UNITED STATES PATENT AND TRADEMARK OFFICE

APPLICATION NO.	FILING DATE	FIRST NAMED INVENTOR	ATTORNEY DOCKET NO.	CONFIRMATION NO.
10/050,539	01/18/2002	Sunao Ishizaki	NA04	7739

Office Action Summary

DETAILED ACTION

Fig.5

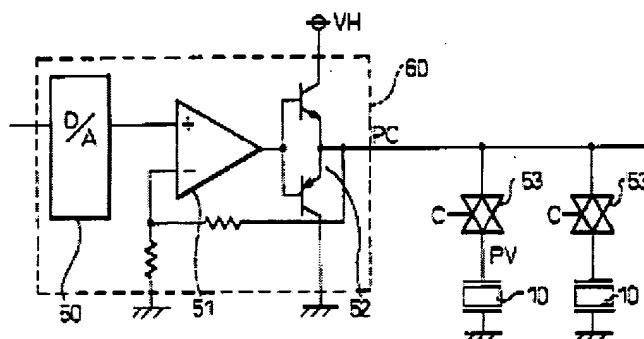
a waveform generator (FIG. 5, element 60) for generating the drive waveform signal (FIG. 5);

a power amplifier (FIG. 5, element 51 and 52) for amplifying the drive waveform signal supplied to one input of said power amplifier and outputting it to said piezo-electric actuators (Fig. 5);

a feedback loop (FIG. 5: the resistor connected from the negative input of element 51 to the PC point) including for feeding back a terminal voltage of said piezo-electric actuators to the other input of said power amplifier (Fig. 5).

FIG. 2

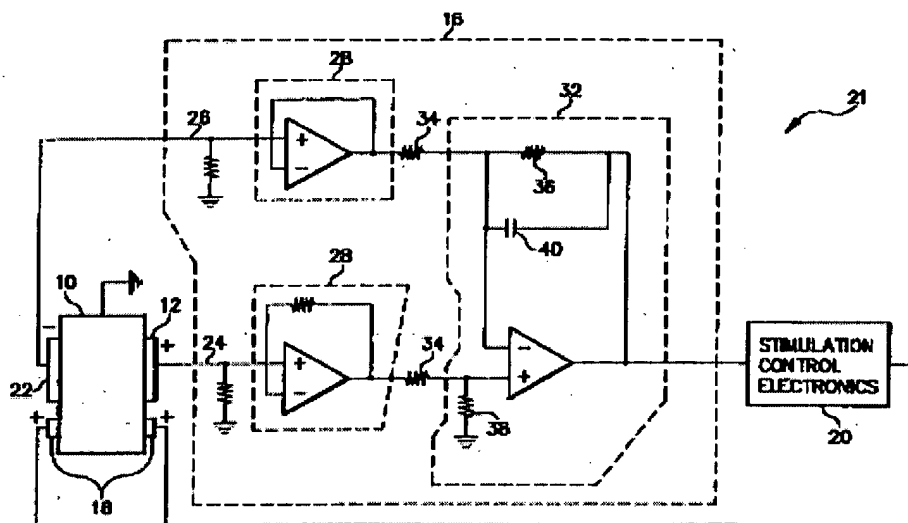
However, Katerberg et al. discloses that the feedback loop for feeding back the terminal voltage of said piezo-electric actuators includes a capacitor for leading to signal phase in high frequency range (FIG. 2, element 40).

Therefore, it would have been obvious for one having ordinary skill in the art at the time the invention was made to include such capacitor as designed by Katerberg et al. into the design of Mitsuhashi et al. because this capacitor prevents oscillation in order to gain the stability of the operation of the amplifier as taught by Katerberg et al. (column 3, line 55-60).

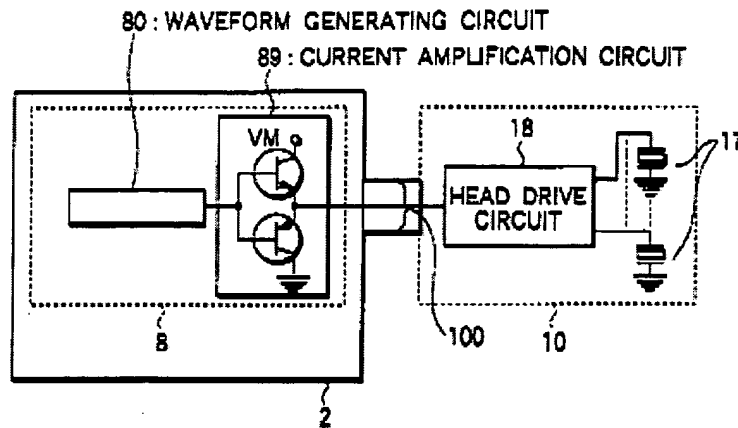
4. Claims 7 and 8 are rejected under 35 U.S.C. 103(a) as being unpatentable over Isamoto (US 6334668) in view of Katerberg et al. (US 5384583).

Isamoto discloses a drive circuit of an ink jet head of a serial type ink jet printer, which includes a carriage mounting nozzles (FIG. 7A) and pressure generating chambers and in which ink droplets are jetted from the nozzles by sharply changing volumes of said pressure generating chambers (FIG. 13A, element 234) filled with ink by applying drive waveform signal to piezo-electric actuators (FIG. 13A, element 239) provided corresponding to said respective pressure generator chambers while moving said carriage reciprocally in a direction perpendicular to a feeding direction of a printing sheet (FIG. 1), comprising:

a control circuit board (FIG. 12, element 2) mounting a waveform generator (FIG. 1, element 80) for generating a signal for driving said ink jet head, a power amplifier (FIG. 12, element 89) for amplifying the output signal of said waveform generator, an image memory for storing printing data (FIG. 8, element 4-5), and a data transmitter for transmitting the image data stored in said image memory as a serial data thereon (FIG. 1, element 9);

an intermediate circuit board (FIG. 11A, element 18) mounted on said carriage and mounting a data receiver (FIG. 11A, element 13) for receiving the serial data from said data transmitter, transfer gates (FIG. 11A, element 160) for selecting piezo-electric actuators (FIG. 11A, element 17) on the basis of the received printing data and a level shifter (FIG. 11A, element 160) for matching voltage levels of said data receiver and said transfer gates thereon;

a cable for connecting said control circuit board and said intermediate circuit board each other (FIG. 12, element 100);

Isamoto does not disclose a negative feedback loop including a resistor and a capacitor.

However, Katerberg et al. discloses a negative feedback loop including a resistor (FIG. 2, element 36) and a capacitor (FIG. 2, element 40) to prevent oscillation of the amplifier (column 3, line 55-59).

Therefore, it would have been obvious for one having ordinary skill in the art at the time the invention was made to include such negative feedback loop as designed by Katerberg et al. into the design of Isamoto because this negative feedback loop prevents oscillation in order to gain the stability of the operation of the amplifier as taught by Katerberg et al. (column 3, line 55-59).
